PETITION NO. 1174
 LADDER 4, LLC
 3396 VINEWOOD
 DETROIT, MICHIGAN 48208
 JAMES CADARIU
 PHONE NO. (313) 515-2017

- REQUEST ENCROACHMENT
 (With Fencing & Seating)

REQUEST ENCROACHMENT
 INTO GRAND BLVD
 AT 3396 VINEWOOD

NOTICE OF PROPOSED CHANGE IN PROPERTY

DRWG. NO. X 1174

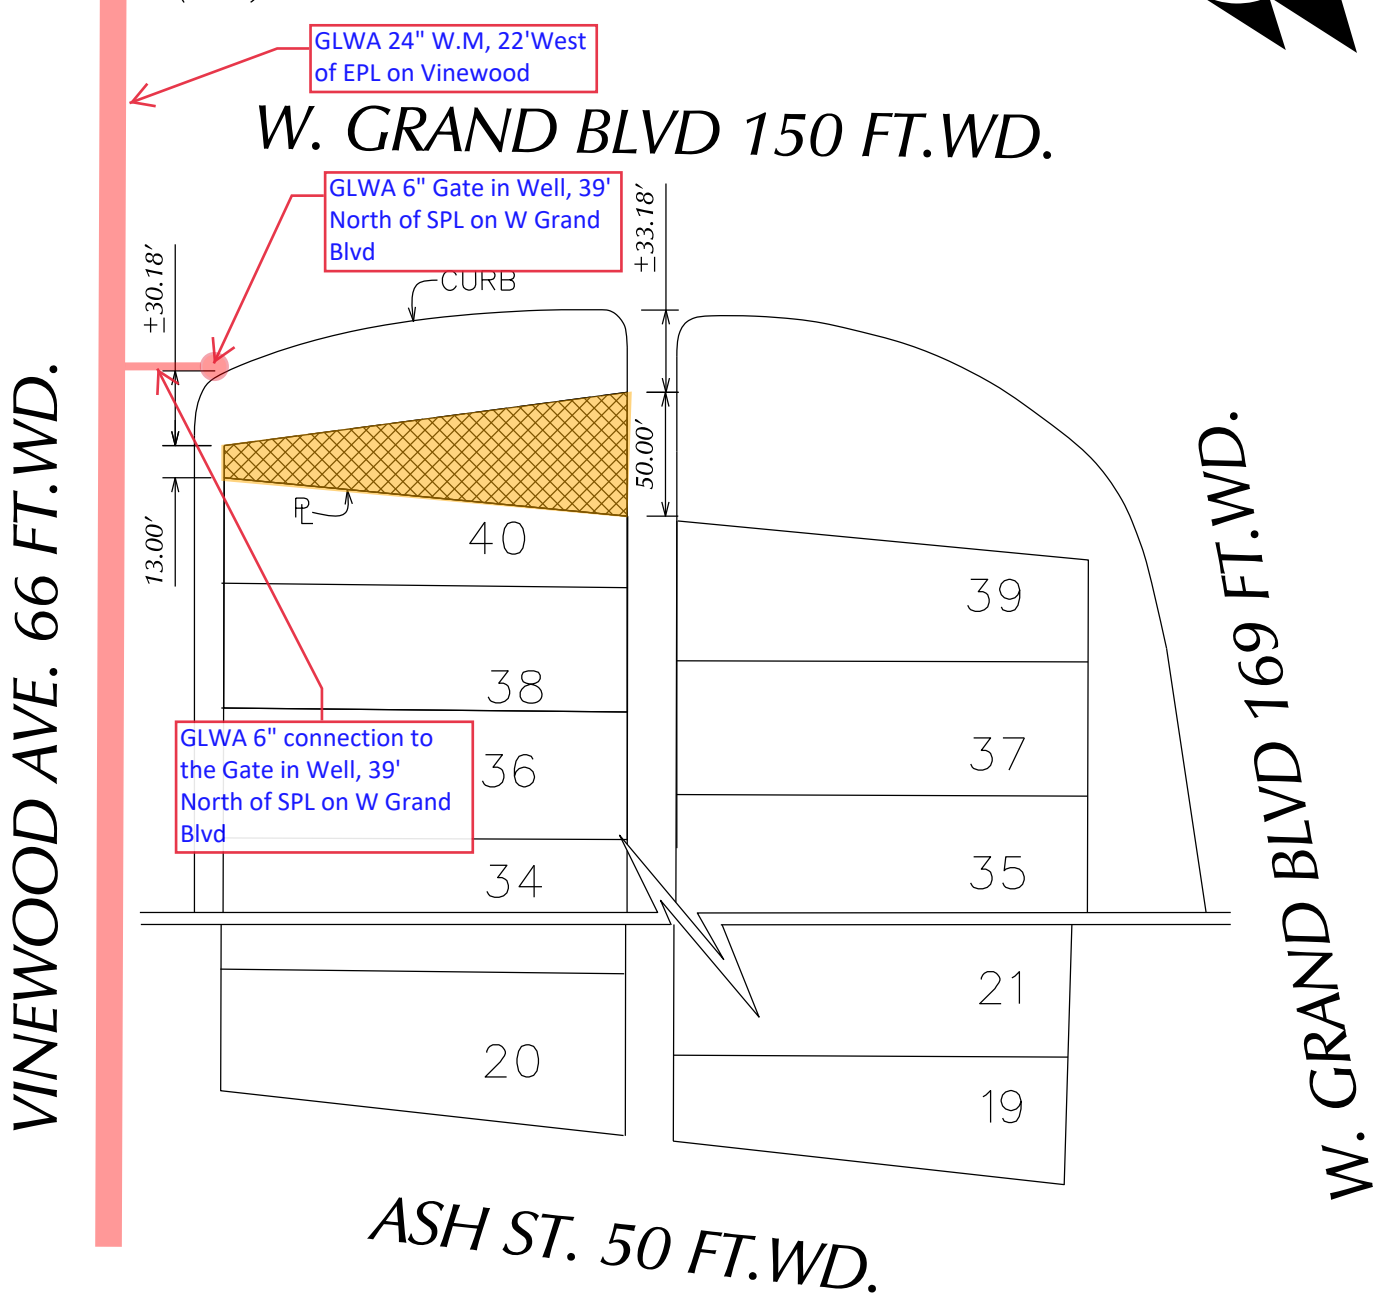
- Not Involved
- Involved; but no objections to the property change. GLWA has a 6" Gate Valve at the curb intersection of Vinewood and W Grand Blvd and 6" Water main connection to the 6" Gate valve from 24" W.M on Vinewood Street.
- Involved; objection to the property change.
- Involved; the nature of our services and the estimated costs of removing and/or rerouting such services are:
